Docket No.: 52-011

AR-07-0801

Southern Nuclear Operating Company  
Vogtle Early Site Permit Application  
Response to Requests for Additional Information Letter No. 6 Involving Geology/Seismology

**Response to March 15, 2007 RAI Letter No. 6**

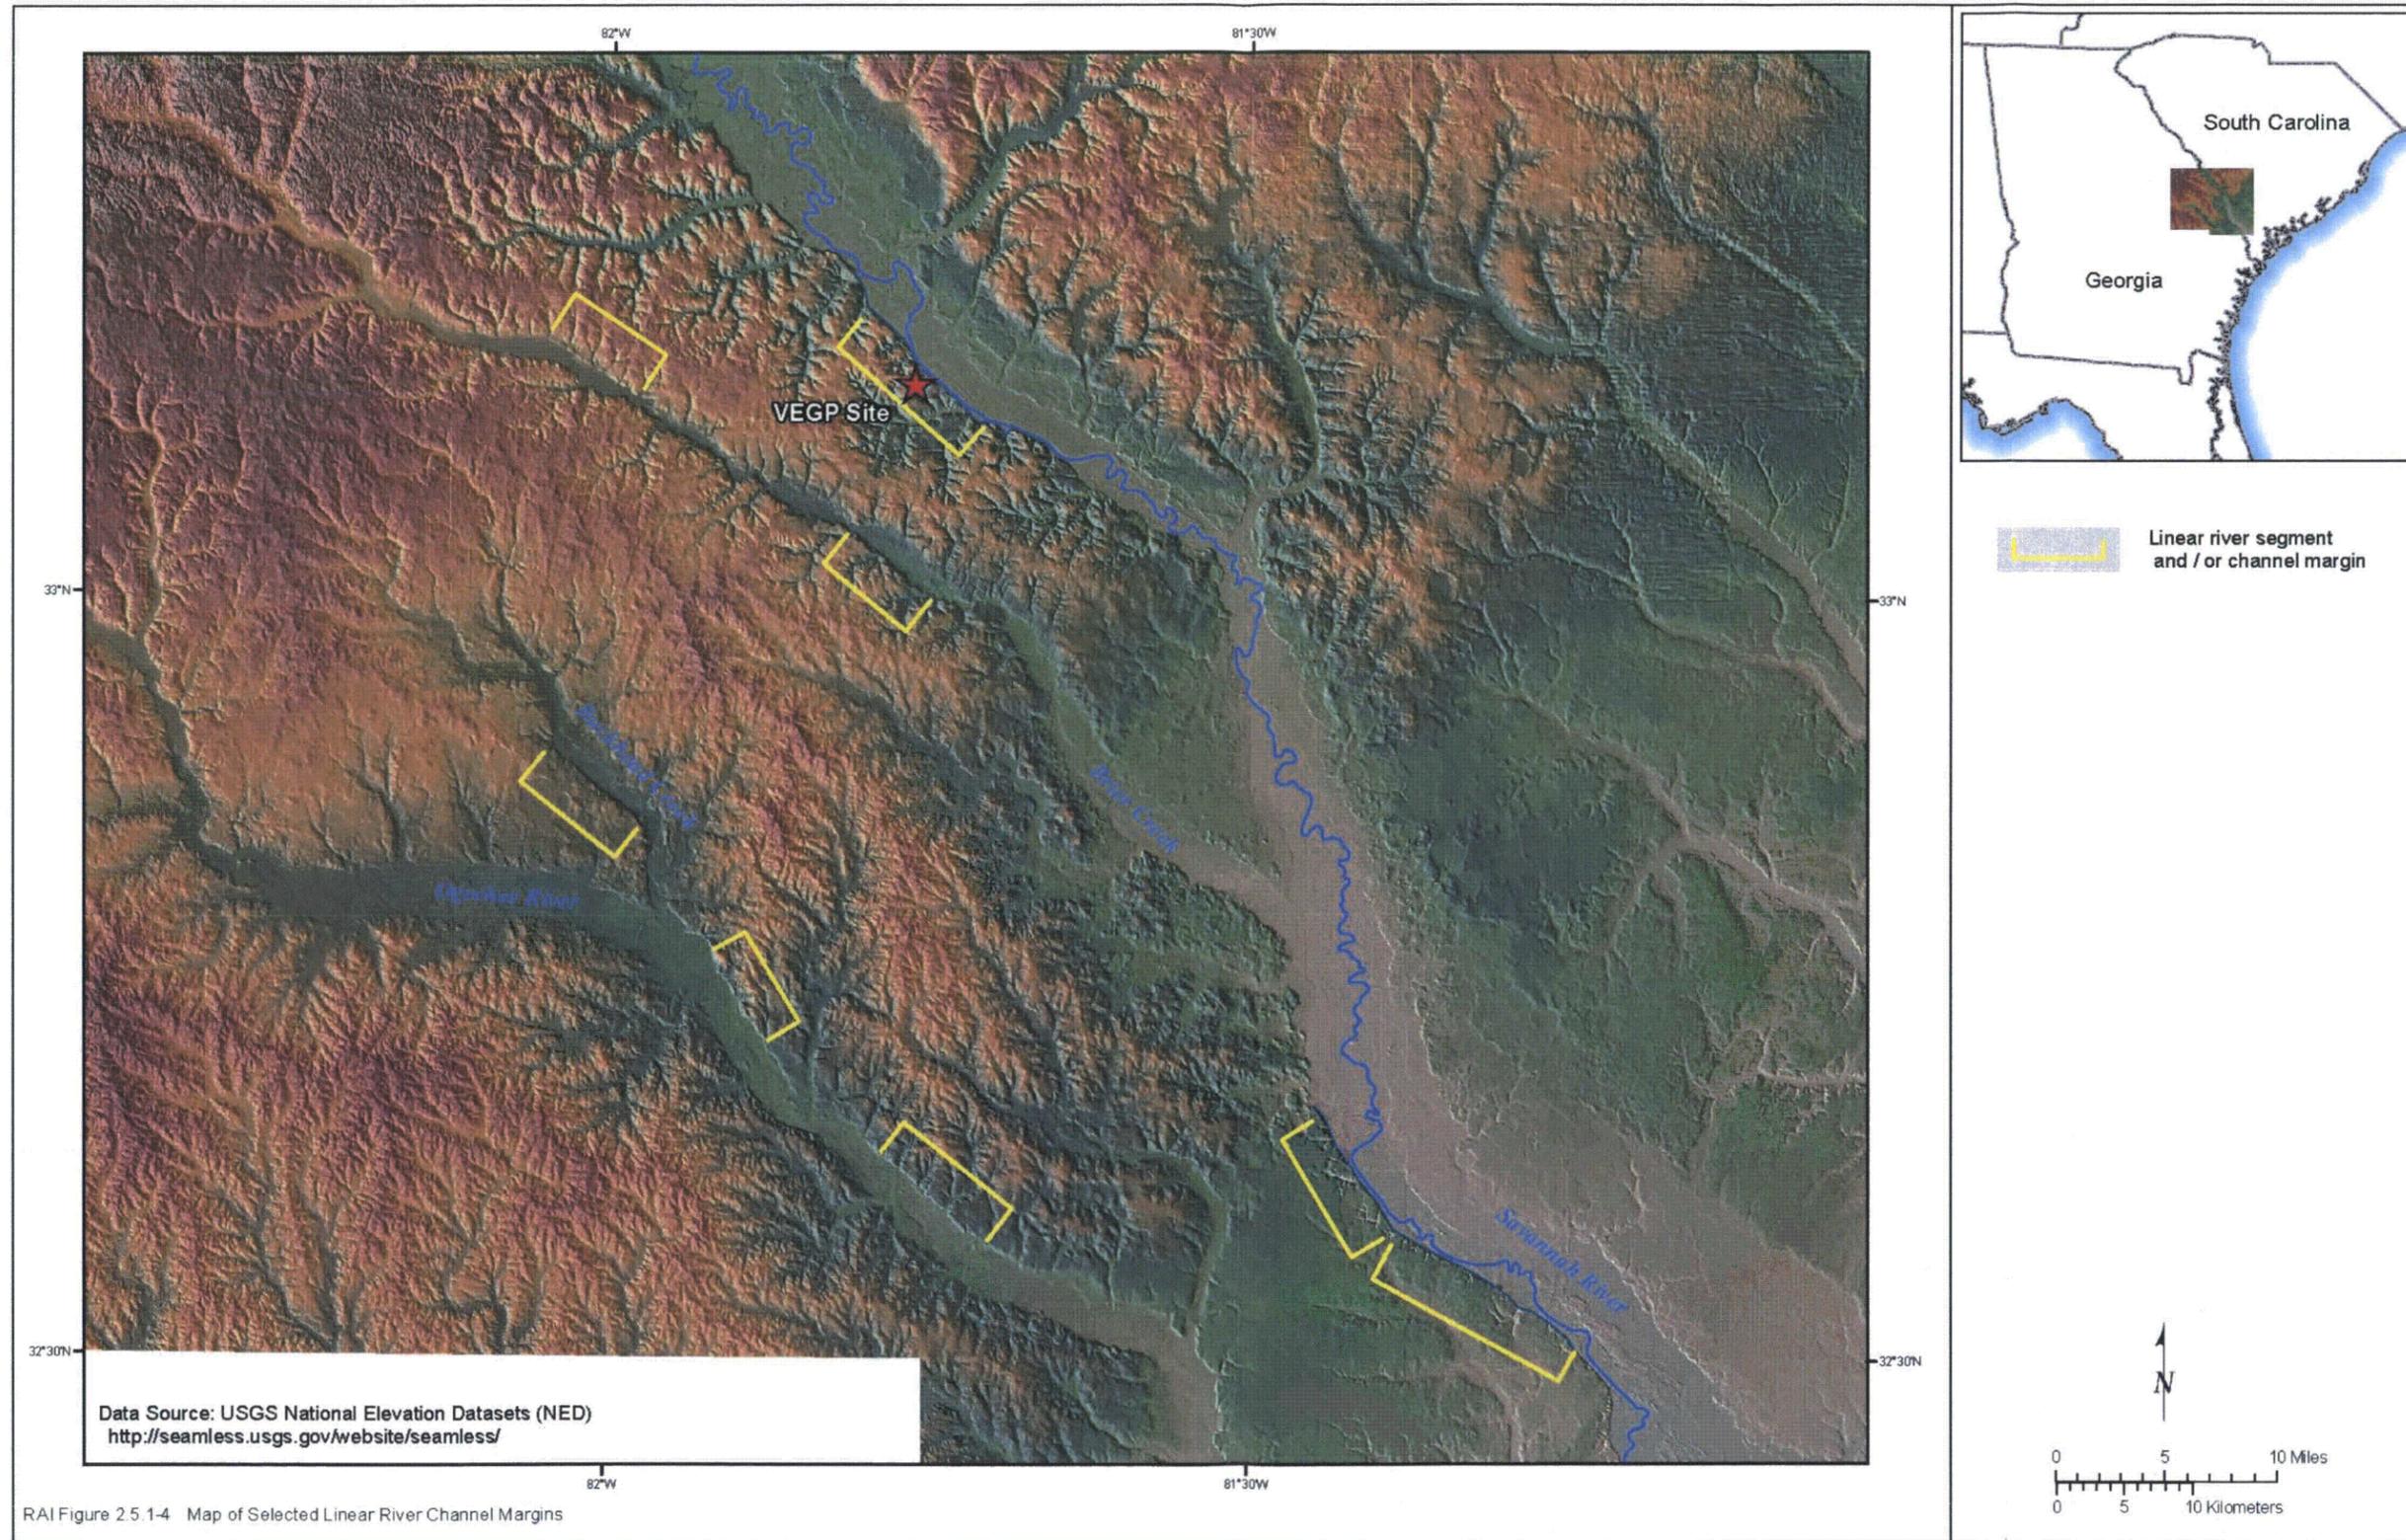
**2.5.1-4** SSAR Figure 2.5.1-29 shows the Savannah River to be relatively straight in the site area in the vicinity of (i.e., southeast of) the proposed surface trace of the Pen Branch Fault. Section 2.5.1.2.1 of the SSAR describes the Savannah as incised at that location.

**Please provide information to address why the Savannah River is straight and incised at a position that appears to correspond with the location of the Pen Branch Fault “block” on the southeastern side of the fault.**

The Pen Branch fault projects across the Savannah River near the upstream limit of a linear segment of the channel in the vicinity of the VEGP site. The relatively straight portion of the river is incised along the southwestern margin of the floodplain to form the bluffs on the Georgia side of the river. While

characteristics of rivers and channels can change or respond where they cross locations of tectonic activity, there are many other fluvial, geomorphic, eustatic, and other non-tectonic factors that control channel morphology and sinuosity.

It is not readily apparent what factors or combination of factors have produced the linear portion of the Savannah River in question. However, three observations preclude this straight segment of the river from being the result of recent movement of the Pen Branch fault:
